Product Change Notice (PCN)

PCN Number: **PCN-0451100R-02**

Product(s) Affected: SJD1-3201-54

| PREVIOUS CUI DEVICES DETAIL / IMAGE | NEW CUI DEVICES DETAIL / IMAGE |
|--|---|
|  <p>Recommended PCB Layout Top View</p> |  <p>Recommended PCB Layout Top View</p> |

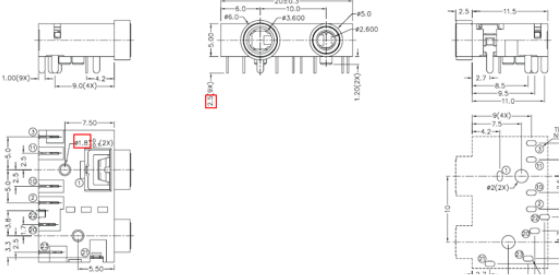
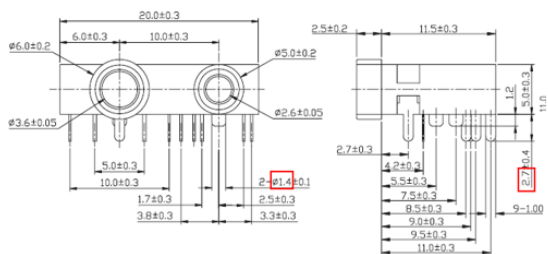
Description of Change: mechanical and material differences as shown below:

| PREVIOUS CUI DEVICES DETAIL / IMAGE | NEW CUI DEVICES DETAIL / IMAGE |

| | MATERIAL | PLATING | DESCRIPTION | MATERIAL | PLATING/COLOR |
|-------------|--------------|---------|-------------|---------------------------|---------------|
| terminal 2 | copper alloy | tin | terminal 2 | stainless steel t=0.20 | tin |
| terminal 3 | copper alloy | tin | terminal 3 | stainless steel t=0.20 | tin |
| terminal 21 | copper alloy | tin | terminal 21 | phosphor bronze t=0.30 | tin |
| terminal 22 | copper alloy | tin | terminal 22 | stainless steel t=0.20 | tin |
| terminal 23 | copper alloy | tin | terminal 23 | phosphor bronze t=0.25 | tin |
| bushing | brass | nickel | bushing | copper alloy | nickel |
| plastic | PBT | | housing | PAB6+GF15% (UL94HB) | black |
